Project	IEEE 802.16 Broadband Wireless Access Working Group < http://ieee802.org/16 >
Title	Text Clarification and Clean-up for the MAC Header
Date Submitted	2005-04-28
Source(s)	Hang Zhang, Mo-Han Fong, Peiying Zhu, mhfong@nortelnetworks.com Wen Tong Nortel Networks
Re:	IEEE P802.16e/D7-2005
Abstract	This contribution provides text clarification and clean-up regarding the MAC header
Purpose	Review and Adopt the suggested changes into P802.16e/D7
Notice	This document has been prepared to assist IEEE 802.16. It is offered as a basis for discussion and is not binding on the contributing individual(s) or organization(s). The material in this document is subject to change in form and content after further study. The contributor(s) reserve(s) the right to add, amend or withdraw material contained herein.
Release	The contributor grants a free, irrevocable license to the IEEE to incorporate material contained in this contribution, and any modifications thereof, in the creation of an IEEE Standards publication; to copyright in the IEEE's name any IEEE Standards publication even though it may include portions of this contribution; and at the IEEE's sole discretion to permit others to reprod

Figure 20e—Bandwidth request and uplink sleep control header

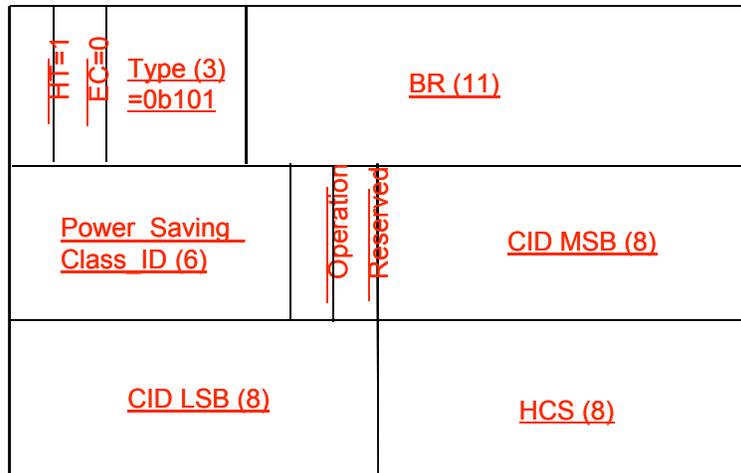
[Replace Table 7e by a new Figure and Table below, so as to be consistent with other header description]

Table 7e—Description of the fields of Bandwidth request and uplink sleep control header

<u>Name</u>	<u>Length (bits)</u>	<u>Description</u>
<u>HT</u>	<u>1</u>	<u>Header Type = 1</u>
<u>EC</u>	<u>1</u>	<u>Always set to zero</u>
<u>Type</u>	<u>3</u>	<u>Type = 0b101</u>
<u>BR</u>	<u>11</u>	<u>Bandwidth Request: The number of bytes of uplink bandwidth requested by the MS. The bandwidth request is for the CID. The request shall not include any PHY overhead. It is aggregate BW request.</u>
<u>Power Saving Class ID</u>	<u>6</u>	<u>Power Saving Class ID</u>
<u>Operation</u>	<u>1</u>	<u>1: to activate Power Saving Class 0: to deactivate Power Saving Class</u>
<u>Reserved</u>	<u>1</u>	<u>=</u>
<u>CID</u>	<u>16</u>	<u>Basic CID of the MS for which the bandwidth request and uplink sleep control header is sent</u>
<u>HCS</u>	<u>8</u>	<u>Header Check Sequence (same usage as HCS entry in Table 5).</u>

Figure 20bg— Feedback header with CID field

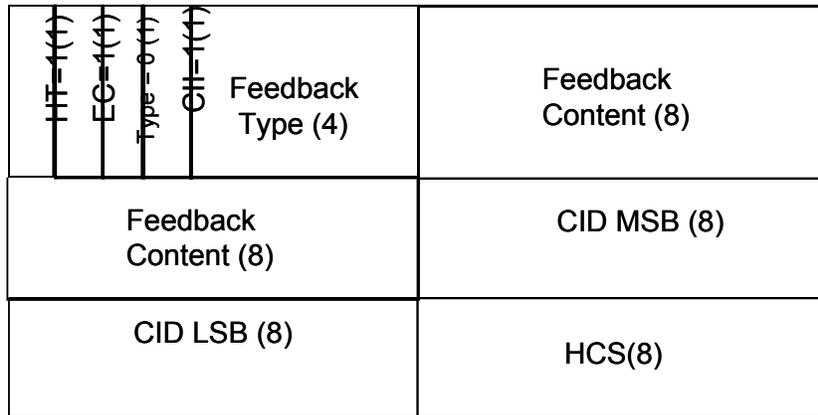
[Replace drawing in Figure 20b in p802.16e/D7 with the following drawing]

- a) The length of the header shall always be 6 bytes.
- b) The HT field is set to 1, ~~and~~ the EC field is set to 1 and the Type field is set to 0, which indicates the feedback header type.
- c) The Feedback type field shall be set according to Table 7i.
- d) The CII field (CID Inclusion Indication) shall be set to 1 for the header with CID field and set to 0 for the header without CID field.
- e) The Feedback Content field shall be set accordingly based on the value of the feedback type field.

Figure 20eh—Feedback header without CID field

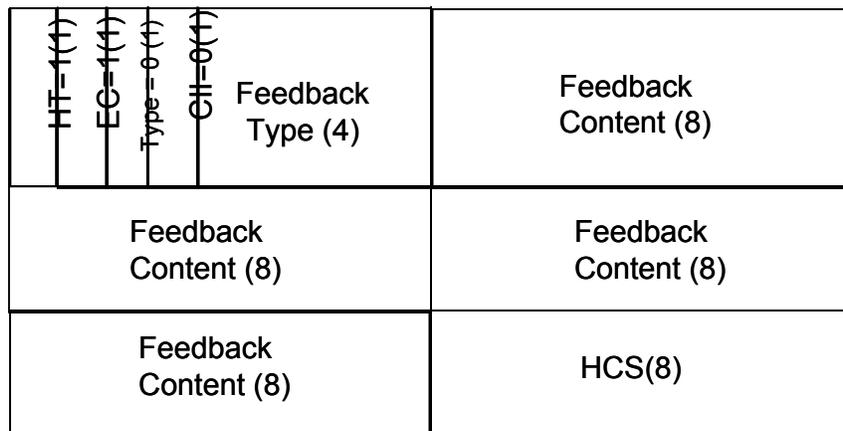
[Replace drawing in Figure 20c in p802.16e/D7 with the following drawing]
